Change Order, Construction Manager as Adviser Edition

Christian County High School

Change Order Number: 007

Project:	Christian County High School 5185 Ft. Campbell Blvd Hopkinsville, KY 42240	PR No.:	001
		Date:	October 13, 2023
Owner:	Christian County Public Schools 222 Glass Ave Hopkinsville, KY 42240	Project Number:	2106-204
		Contract for:	
To:	Tim Geegan Alliance Corporation 116 E. College Steet Glasgow, KY 42141		
RE:	State Required Egress Door Modifications, Misc Door Changes and Minor structural clarifications.

PR-1S1

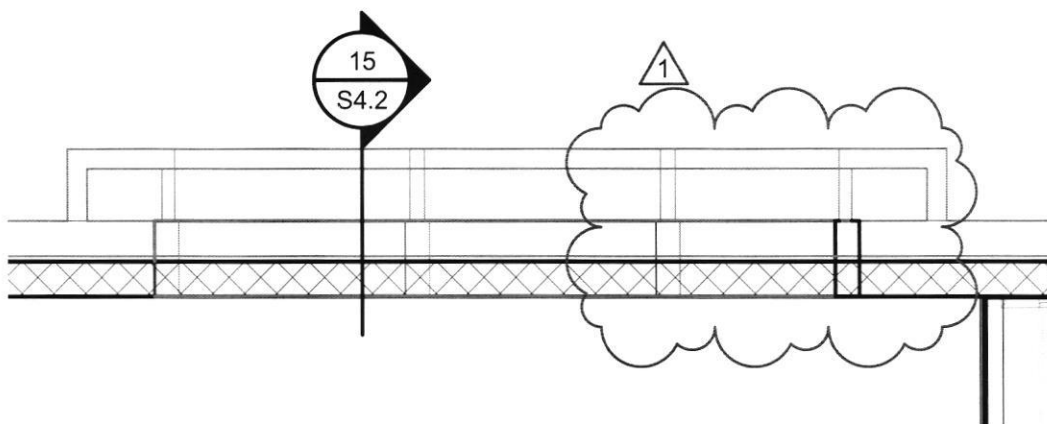
- 9) See Details 2/PR-1S1, 1/PR-1S3, 1/PR-1S6, 1/PR-1S7, 1/PR-1S9, 1/PR-1S10 for clarification on footing requirements.

PR-1S5

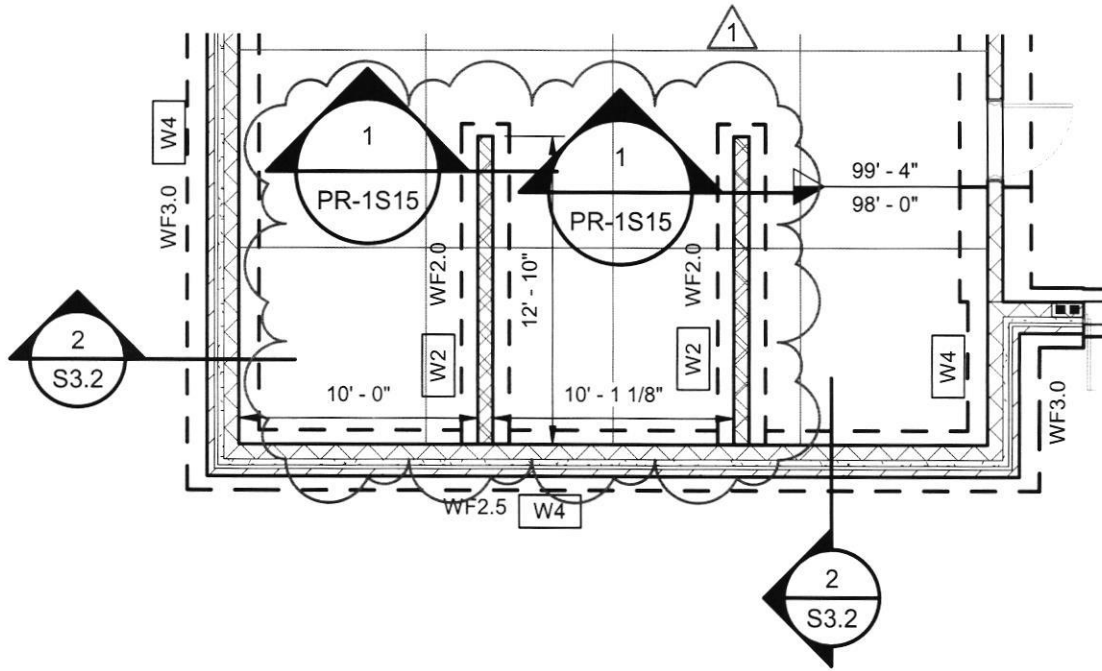
- 10) See 1/PR-1S5 for clarification on CMU wall height adjacent to CLs FF/F5
- 11) See 1/PR-1S8 for Area G lintel clarification.
